TITLE: Oxygen System Hazards Analyses

PRINCIPAL INVESTIGATOR: Joel Stoltzfus

REPORT DATE: October 1996

TYPE OF REPORT: Final

Figure 3
Recharger Oxygen Support Equipment Subsystem

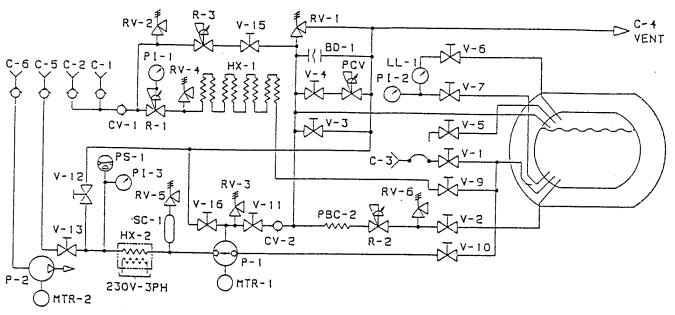
The ROSE I subsystem is shown in Figure 3. LOX, at a maximum pressure of 120 psig (0.83 MPa), flows from the storage tank through either a low-pressure line or a high-pressure line. The low-pressure line has a passive heat exchanger, HX-1, which vaporizes the gas before it passes through regulator R-1. The high-pressure line has a LOX pump, P-1, which pumps high-pressure LOX into HX-2. High-pressure GOX flows through valve V-13 and out to the HOBS.

The accumulator in this system, shown as SC-1 in Figure 3, was treated as if it were a section of stainless steel tubing. Therefore, no hazards analysis discussion is included for this component.

If any of these valve components failed by external leakage, the ROSE I's internal housing would become oxygen-enriched. Further analysis should be done on the electrical contacts of heat exchanger HX-2 to determine if an ignition hazard exists.

There is a possibility of contaminating the LOX tank of the ROSE I if the PCV failed open, allowing air or moisture to build up in tank. Consequently, contamination happens even during normal filling operations with impurities in the LOX. Hence, procedures should be implemented for detailed maintenance of the tank, most importantly, purging the tank on a regular basis. It is recommended that this issue be investigated. However, this is ultimately a purity issue for the breathing gas, not a flammability issue.

If relief valve RV-4 fails closed, there is a possibility of a line rupture. The adjacent heat exchanger line is aluminum, which is most susceptible to this hazard. WSTF data from a fire that occurred in the testing of a space suit for NASA indicates that fresh metal exposure of aluminum is a credible ignition source.

Kindling chain is considered *probable* in this high-pressure setting. If oil or other hydrocarbons contaminate the dead-end of the Bourdon tube and ignite, the fire can propagate and burn the stainless steel Bourdon tube. This hazard could be eliminated by changing the Bourdon tube material to brass, or implementing a bleed port to allow flow-through cleaning in the Bourdon tube.

The only ignition mechanism of concern is contamination. Contamination resulting from unclean hoses may lead to *possible* ignition hazards in the system. It is recommended that the connection cap is placed on the component immediately after disconnection to keep the components clean.

The only ignition mechanism of concern is that of particle impact in high-velocity gas. Ignition is *remotely possible* from particles impacting the 90-degree bends in the stainless steel tubing. The maximum velocity of the gas is calculated to be 121 ft/s (37 m/s). Particles have been shown to ignite 316 stainless steel at velocities of 150 ft/s (50 m/s) (Williams, Benz, and McIlroy 1988). This hazard could be eliminated entirely if a filter were strategically placed in the system to catch particles.

Figure 4
Hospital Oxygen Backup System

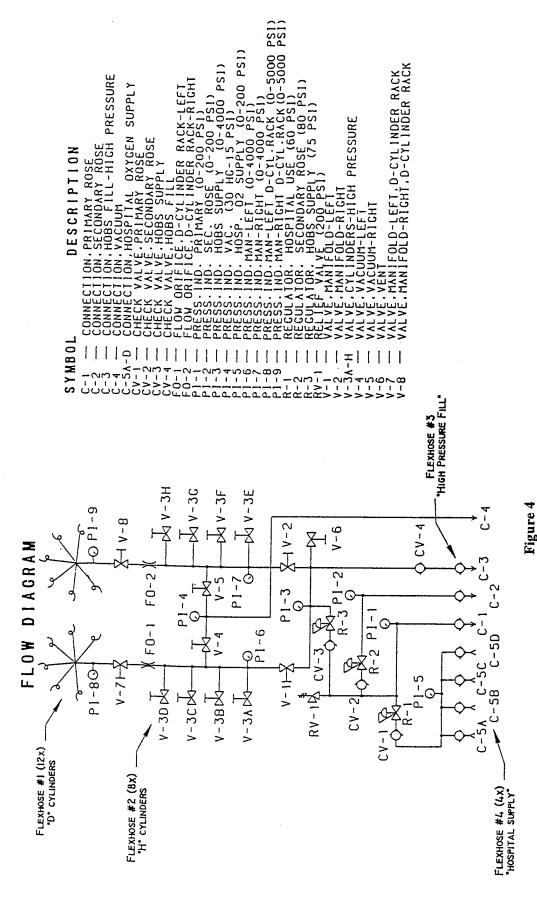
The HOBS is shown in Figure 4. Many components of this system are similar to components on the ROSE I. The operational procedures and conditions of the HOBS were considered and, in some cases, the HOBS components were analyzed only by similarity to their counterparts in the ROSE I. Thus, they were not considered in the HOBS analysis. Table 1 shows the components of the HOBS that were analyzed by similarity to their ROSE I counterparts.

In considering the HOBS on a system level, care should be taken to ensure the system is free of contamination. This can be done by performing visual inspections of often-removed components and connections, as well as avoiding any hydrocarbon oil or grease during servicing.

The following is a general note that applies to all flexible hoses on the HOBS: It is recommended that operating procedures specify that the ends of all flexible hoses are to be inspected for cleanliness before connection.

Adiabatic compression was considered a *remotely possible* source of ignition. The critical length distance piece on the CGA fittings was calculated as recommended in ASTM STP 986 (Barthelemy and Vagnard 1988). It was determined that the distance piece given on the flexible hose is sufficient.
